ZONING COMMITTEE STAFF REPORT

1. **FILE NAME:** CVS Pharmacy **FILE #** 15-180-427
2. **APPLICANT:** Velmeir Companies **HEARING DATE:** December 10, 2015
3. **TYPE OF APPLICATION:** Conditional Use Permit
4. **LOCATION:** 30 Fairview Ave S, NE corner at Grand Avenue
5. **PIN & LEGAL DESCRIPTION:** 042823420027, Elmer & Morrison's RE Lots 11 Thru Lot 16 Block 3
6. **PLANNING DISTRICT:** 14 **PRESENT ZONING:** T2
7. **ZONING CODE REFERENCE:** §65.513, §61.501, §61.502
8. **STAFF REPORT DATE:** 12/3/15 (Revised 12/21/15) **BY:** Mike Richardson
9. **DATE RECEIVED:** November 19, 2015 **60-DAY DEADLINE FOR ACTION:** January 18, 2016

A. **PURPOSE:** Conditional use permit for drive-through service with modification of special conditions requiring drive-through lanes and service windows to be at least 60 feet from residential property and requiring drive-through lanes not to be between the principal structure and a public street.

DRAWN BY: WBS
DATE: 12/17/15
JOB NUMBER: 14623
TITLE: SITE PLAN
SHEET NUMBER: C2-1
COMMENTS:

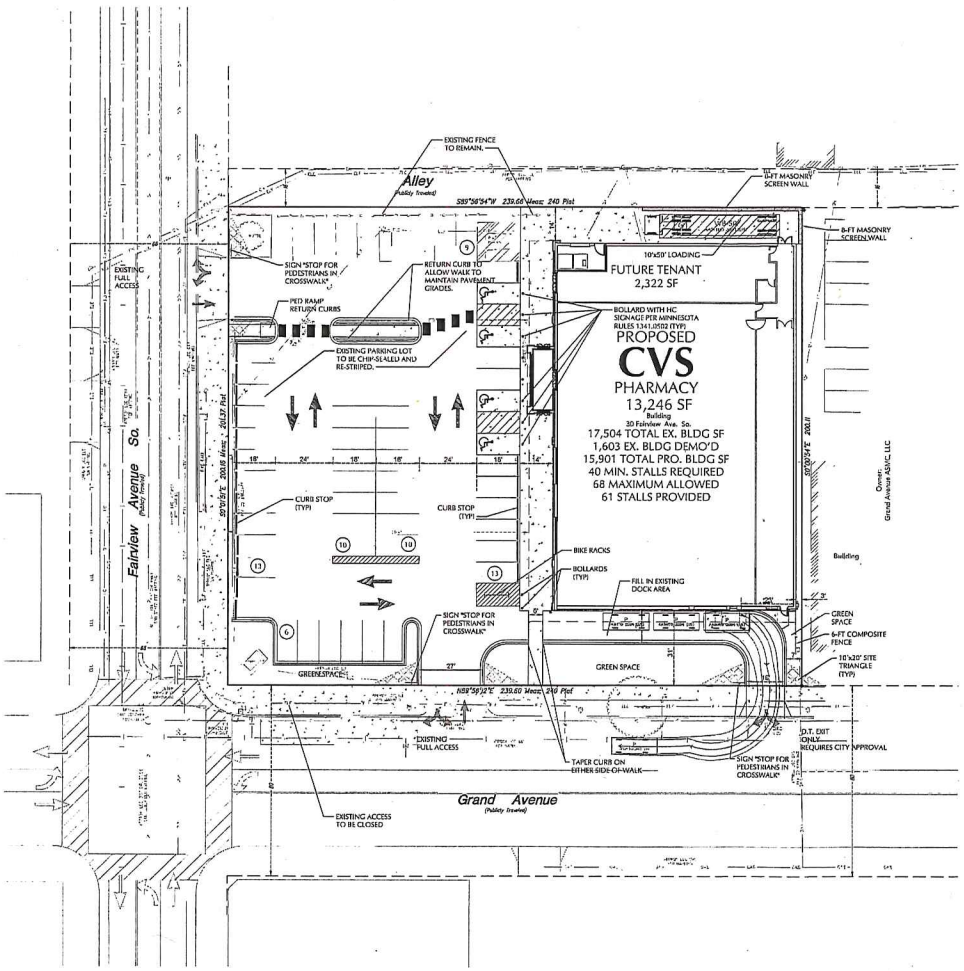
sixty (60) feet from the closest point of any residentially zoned property or property occupied with a one-, two-, or multiple-family dwelling. This condition is not met. The proposed drive-through is located between the south side of the building and Grand Avenue. The eastern edge of the drive-through lane is eight (8) feet from the lot line of the multifamily residential property to the east. The applicant has requested a modification of this condition.

(b) *Points of vehicular ingress and egress shall be located at least sixty (60) feet from the intersection of two streets and at least sixty (60) feet from abutting residentially zoned property.* This condition is not met. While the westernmost curb cut on the Grand Avenue side is approximately eighty (80) feet from the intersection, the eastern curb cut of the drive-through lane is eight (8) feet from abutting residentially zoned property to the east. The applicant has requested a modification of this condition.

(d) *A six-foot buffer area with screen planting and an obscuring wall or fence shall be required along any property line adjoining an existing residence or residentially zoned property.* This condition is met. The site plan shows an eight (8) foot planted buffer adjacent to the residentially zoned property to the east.

(f) *There shall be no more than one (1) drive-through lane and no more than two (2) drive-through service windows, with the exception of banks, which may have no more than three (3) drive-through lanes.* This condition is met. The site plan shows one (1) drive-through lane and one (1) service window.

(g) *The number of curb cuts shall be minimized. In light rail station areas, there shall generally be no more than one (1) curb cut on a block face per drive-through. Drive-through sales and services are prohibited along the entire length of block faces adjacent to light rail transit station platforms.* This condition is met. The entry curb cut serves both the drive-through and the parking lot, and there is a single curb cut for the drive-through exit. The site plan shows that an existing curb cut on Grand Avenue closer to the intersection will be eliminated, resulting in two total curb cuts.

(b) *The use will provide adequate ingress and egress to minimize traffic congestion in the public streets.* This condition is met. The site plan shows the closure of the curb cut closest to the intersection. The drive-through exit would be one way to the street and would not negatively impact the flow of traffic within the public street.

The criteria in §61.502 for modification of these special conditions are not met. The existing building introduces constraints within which the applicant must work. Due to spatial limitations on other sides of the building, the location of the drive-through on the site plan is the only possible location where one could be located. The applicant has demonstrated a good effort to design the landscaping and vehicular ingress and egress to reduce the impact on the adjacent residential property. However, while a drive-through is a common accessory use for the operation of a pharmacy, it can operate without a drive-through. For example, the CVS pharmacy at the corner of Grand Avenue and Oxford Street and the Walgreens at Grand Avenue and Grotto Street do not have drive-through lanes. Therefore, strict application of the special conditions would not unreasonably limit or prevent otherwise lawful use of the property and existing structure, and would not result in exceptional undue hardship to the owner of the property. There is also a potential safety hazard introduced when drive-through circulation is crossed with pedestrian movement on the sidewalk.

I. **STAFF RECOMMENDATION:** Based on Finding 4 that strict application of the special conditions *would not unreasonably limit or prevent otherwise lawful use* of the property and existing structure, Findings 2(a) and 2(b) that the location of the drive-through in relation to the building, street, and residential property does not meet the required conditions of drive-through lanes in T2 districts, and Finding 3(c) that the drive-through as proposed would be detrimental to the existing character of the development in the immediate neighborhood, staff recommends denial of the conditional use permit for drive-through service with modification of special conditions requiring drive-through lanes and service windows to be at least 60 feet from residential property and requiring drive-through lanes not to be between the principal structure and a public street.
